Rezoning Transportation Analysis

Petition Number: 2017-166

General Location Identifier: 06115109

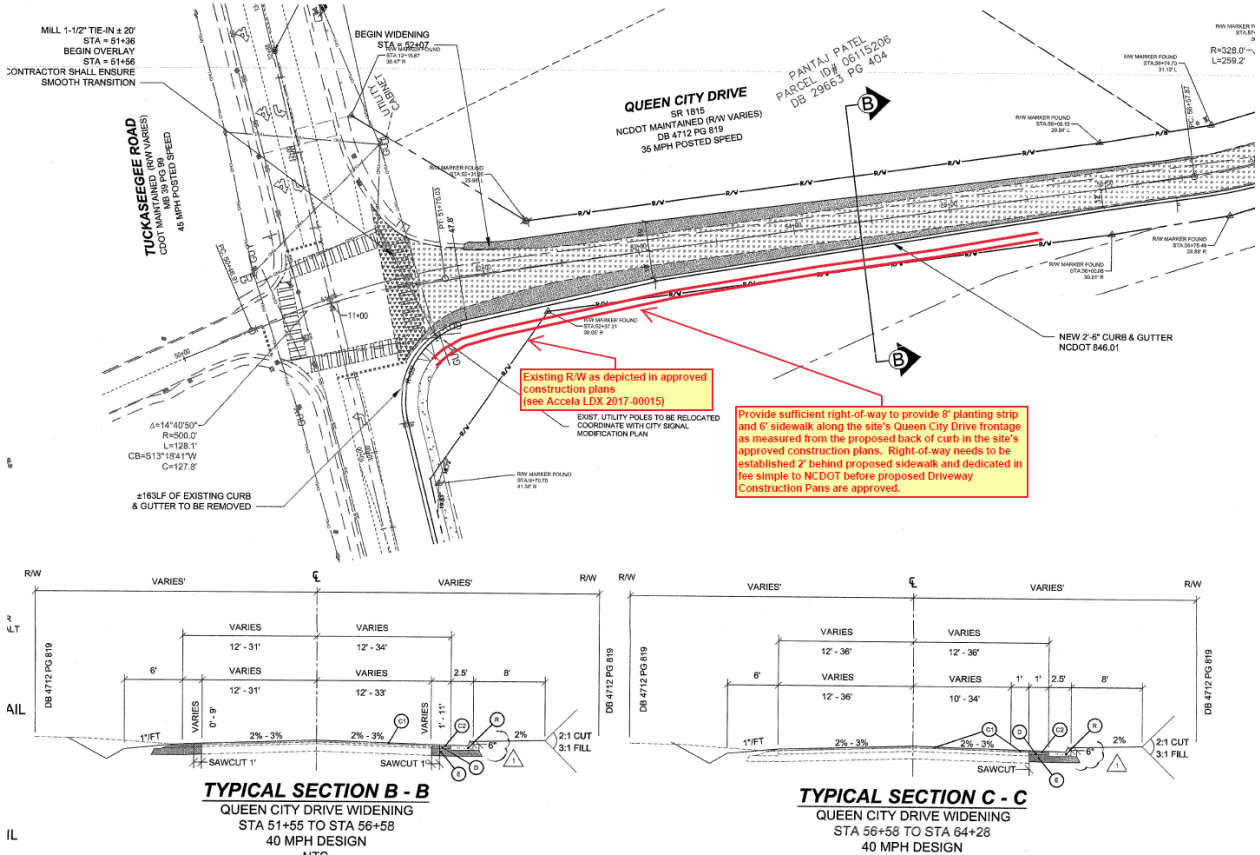
- ~~Traffic Impact Study/Transportation Technical Memorandum is not needed for the complete review of this petition.~~
- The petitioner should revise the site plan and conditional note(s) to provide sufficient right-of-way and implement an 8' planting strip and 6' sidewalk along the site's Queen City Drive frontage as measured

from the proposed back of curb as shown in the site's approved construction plans (see Accela Project No. LDX-2017-00015 approved construction plans below). This requested sidewalk on the west side of Queen Rd. needs to connect to the first site driveway, sidewalk to provide pedestrian from the site's front door to Tuskaseegee Rd. and a CATS bus stop. Right-of-way needs to be established 2' behind proposed sidewalk and dedicated in fee simple to NCDOT before proposed driveway Construction Plans are approved.
